**Before The  
Federal Communications Commission  
Washington, DC 20554**

In The Matter Of	)	
	)	
Digital Audio Broadcasting Systems	)	
And Their Impact On The Terrestrial	)	
Radio Broadcast Service	)	MM Docket No. 99-325

Reply Comments of  
Glen Clark & Associates

**FIGURE 3 –LEAKAGE MECHANISM IN THE SECOND-ADJACENT CHANNEL, DIGITAL-INTO-ANALOG CASE WITH “WIDEBAND” (GREATER THAN 5 kHz) RECEIVER**

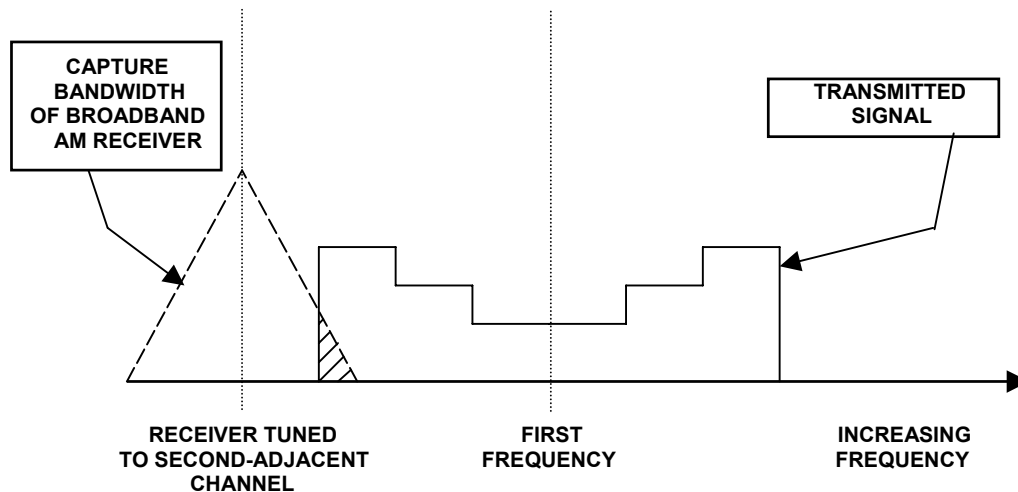
Figure 5 in the attached Appendix B shows that the "primary sidebands" are, in fact, the primary contributor to interference in the first-adjacent channel case. And Figure 3 in the attached Appendix B shows that the "primary sidebands" are the only contributor to interference in the second-adjacent channel case. As a result, reducing the power in the primary sidebands will mitigate both first- and second-adjacent channel interference. One change will fix two problems.

Figure 3 shows this proposed digital signal presented with the same analog receiver bandpass from Figure 1. The proposed digital signal extends 5 kHz further toward the passband of a receiver tuned to a second-adjacent channel station than did the analog signal in Figure 1. Figure 3 shows that, for a receiver with a passband of more than 5 kHz, some of the energy from the transmitted digital signal falls within the capture bandwidth of the receiver. As most analog receivers employ simple envelope detectors which do not reject uncorrelated energy<sup>7</sup>, the digital energy in the crosshatched area of overlap shows up in the receiver's speaker. The larger the crosshatched area, the more leakage there will be.

Clear Channel has recommended that the proposed IBOC standard be modified slightly by reducing the power permitted in the "primary" sidebands by 6 dB or more. The primary sidebands are those sidebands which are more than 10 kHz but less than 15 kHz removed from the carrier frequency.

**FIGURE 5 – LEAKAGE MECHANISM IN THE FIRST-ADJACENT CHANNEL, DIGITAL-INTO-ANALOG CASE**

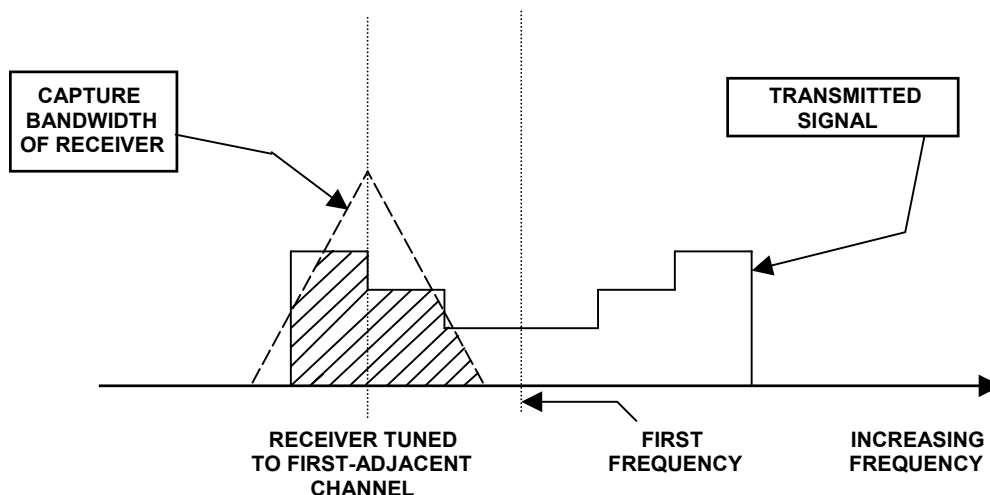
Figure 5 illustrates the leakage mechanism for first-adjacent channel, Digital-Into-Analog leakage. It is immediately obvious that the digital ensembles for a 1<sup>st</sup>-adjacent channel IBOC station will fall within the bandpass of both narrowband and wideband receivers.
